Product Change Notification

PCN-IFC-8599-2023

Business Unit	Product Line Code	Type of Change	Action	Date of Issue
IFC - Industrial	BF7	Product Change	Notify Distributors and	3/22/2023
Field Connectivity		Notification	Field

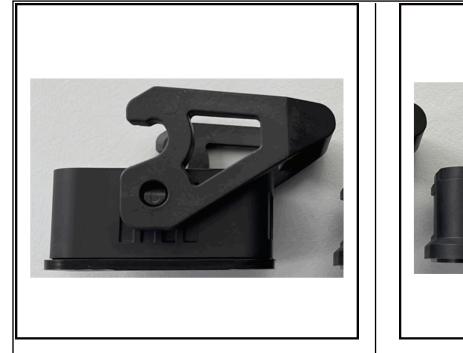
As part of the ongoing improvement process, both the design and material of the HEAVYCON COM panel mounting base housings are being changed. The material is being updated from polyamide to polycarbonate. Also, the external dimensions of the panel-mount base will be slightly altered, though they will not impact intermateability with existing housings. These changes will all improve the rigidity of the connector housing. Furthermore, both the CE logo and the UKCA logo have been molded into the plastic body.
